PREVOST

Warranty Bulletin

96-15

Date: **June 1996**
 Section: **01**
 Subject: **STARTER CABLES**
 Application:

FIGURE 1: STARTER AND TRANSMISSION VUE

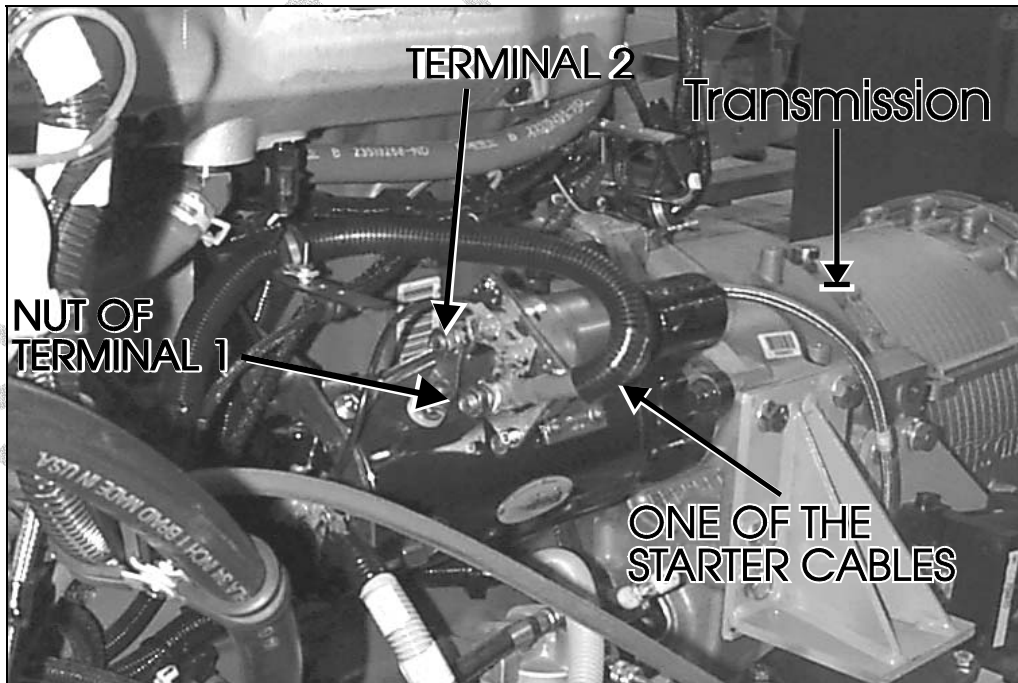
On the above-mentioned vehicles, starter cables installation could be wrong and therefore produce a short circuit. This bulletin is divided in three parts: inspection of cables, cable position changes and cables replacement. **This bulletin is a recall campaign because of the fire risk.**

First of all, it is very important to inspect starter cables. Figure 1 shows the proper position of the alternator cable. If your cable position is the same as it is shown on figure 1, this bulletin is finished. If your cable position is different, look at the table listed below. This table shows all the possible observations of starter cables and the corresponding part to performed.

4. Place correctly alternator cable on terminal 1(positive) as shown on figure 1. The cables must form a loop to avoid contact with terminal 2 (negative) of starter's solenoid.

Warning: Figure 1 shows proper position of the alternator cable to terminal 1. Another cable is attached to terminal 1 (positive)(not shown on figure 1). This is the battery cable. These cables must not touch terminal 2 (negative).

2. Unscrew starter nut on terminal 1(positive) and remove alternator and battery cables (Fig. 1).
3. Insert shrinkable tubing (Prévost #561755) to envelop damage end of alternator cable. This shrinkable tubing should be heated to correctly fit the end of the cable.

5. Tighten starter nut to 20-25 lbf•ft (27-34 N•m) and make sure that cables keep same position. Secure new alternator cable using old clamps and new tie-raps (Prévost # 504637).

FIGURE 2: MAIN POWER COMPARTMENT

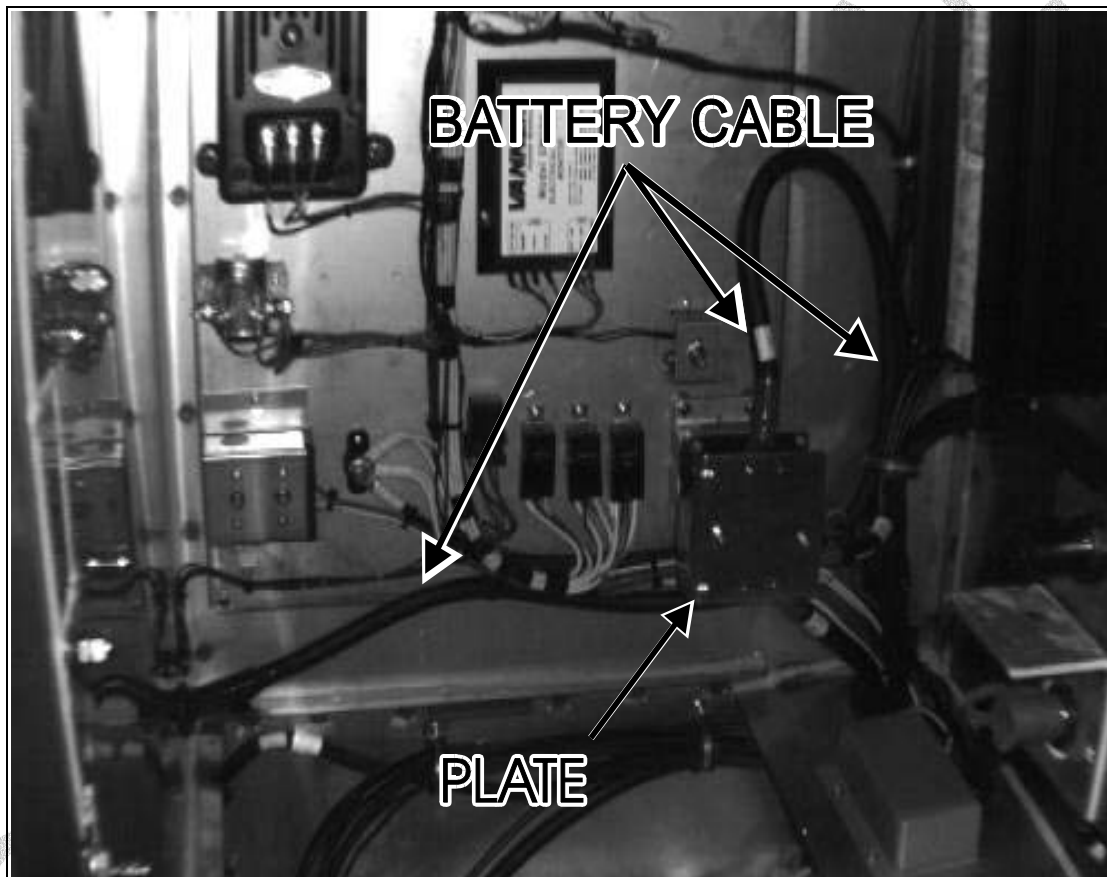
2. Remove damaged starter cables, on terminal 1 (positive). To remove completely battery cable, follow it from starter to the opposite end. For example, on H3 vehicles, opposite end of battery cable is located in main power compartment (Fig. 2) under a plate. To remove the cable, unscrew the two retaining screws and the nut on plate.

Warning: To avoid electric shocks, do not touch simultaneously both terminals on the plate.

4. Fix first end of new alternator cable (Prévost #063297) on alternator with a tightening torque of 32 lbf•pi (43 N•m).
5. Fix on plate (Figure 2, H3 vehicles), the opposite end of battery cable (not starter's end and for proper number check in the above table). If applicable, reinstall plate with retaining screws.
